NUMBER: 08-058-05

Revised Radio Antenna Mast Installation Procedure

2005 - 2006	(DR/DH/D1)	Ram Truck
2005 - 2006	(HB)	Durango
2005 - 2006	(ND)	Dakota
2005 - 2006	(PL)	Neon
2005 - 2006	(PT)	PT Cruiser
2005 - 2006	(RS)	Town & Country/Caravan

Fig. 1 TIGHTENING THE ANTENNA MAST

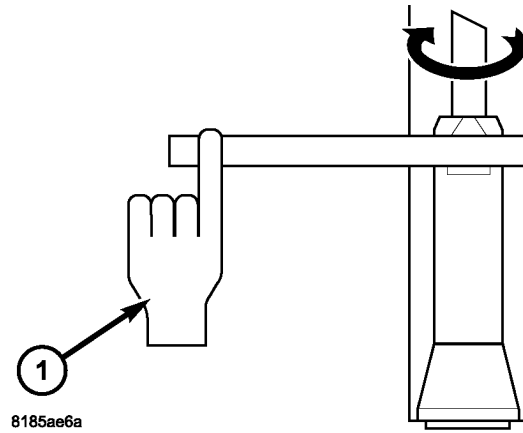
The installation procedure for the radio antenna mast has been revised. Please use the following procedure when installing the antenna mast to the antenna base.

CAUTION: Do not exceed the torque specification in the step below. Damage to the antenna mast and/or base may occur if the tightening torque is exceeded.

1. Install antenna mast to antenna base. Finger tighten the antenna mast until it is fully seated on antenna base; no gap between the mast and base. Using a torque wrench, tighten the antenna mast to 3.4 - 3.6 N·m (30 - 32 in. lbs.) ([Fig. 1](#)).

1 - USE A SHORT WRENCH. TIGHTEN WITH YOUR FINGER, NOT YOUR HAND. TIGHTEN TO 3.4 - 3.6 N·m (30 - 32 in. lbs.) **DO NOT OVERTIGHTEN!**
